Subject: **Request for Modification of Section 404 General Permit No. 198200031 and Section 401 Water Quality Certification, and lifting of Notice of Violation Status** for the Interstate 85 (I-85) widening and interchange improvements from north of NC 73 to north of SR 1280, Cabarrus and Rowan Counties, Divisions 9 and 10. Federal Aid Project No. NHIMF-085-2(61)55, TIP I-3802A.

The North Carolina Department of Transportation (NCDOT) requests modification to the existing General Permit No. 198200031 and associated Water Quality Certification for widening and interchange improvements along I-85 in Cabarrus and Rowan Counties. This project is currently under construction.

Revisions have been made to seventeen impact sites and are discussed in detail below. Two new impact sites are also discussed below (Site 36 and the Troutman waste site).

8/17/99  
 10/17/2019  
 I:\3802A\Hydraulics\PERMITS\_Environmental\Drawings\psh\_contours\13802a\_r.dwg\_psh15B - Mod.dgn  
 PARSONS BRINCKERHOFF

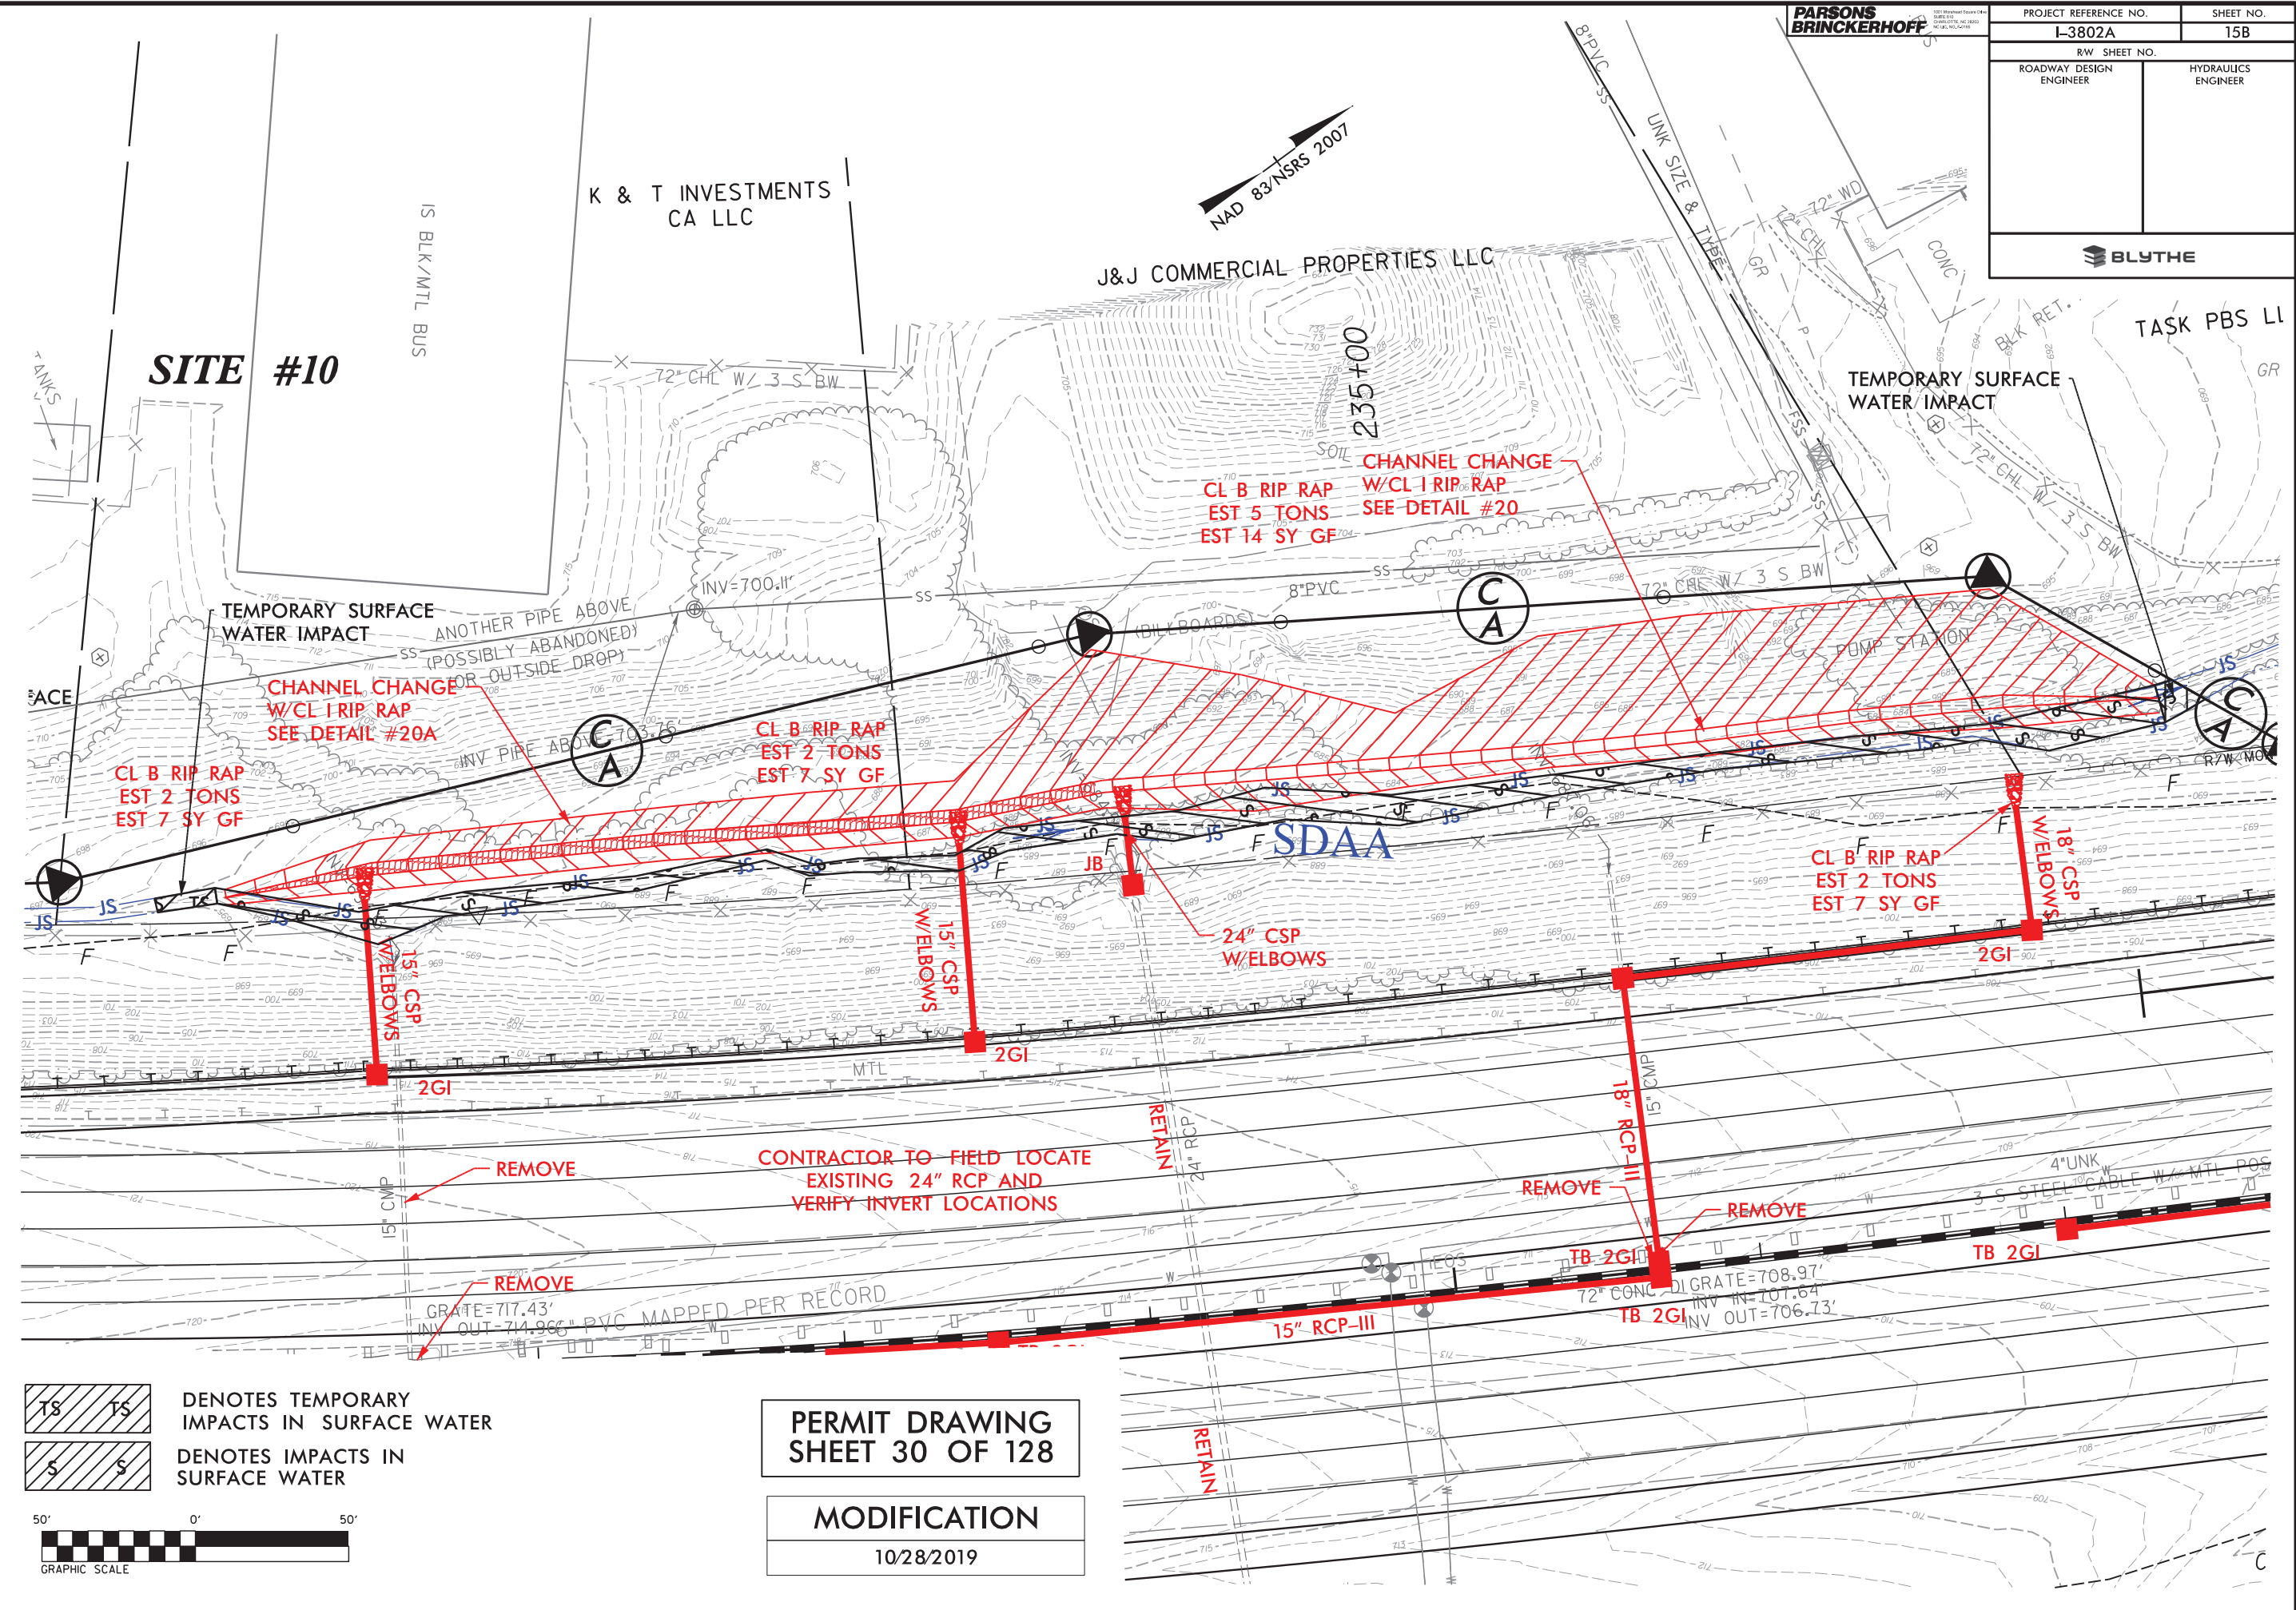
Site 10 (Sheet 15) – The permitted drainage design included a channel change with rip rap only on the banks for stream SDAA. Class I rip rap was installed in the bottom of the channel change for 300 linear feet to provide additional stabilization to address stability concerns. Also, the channel change was shortened by 20 linear feet to make a smoother transition to existing stream channel. Permanent stream impacts were reduced from 666 linear feet to 646 linear feet, which is 20 linear feet of less impacts.
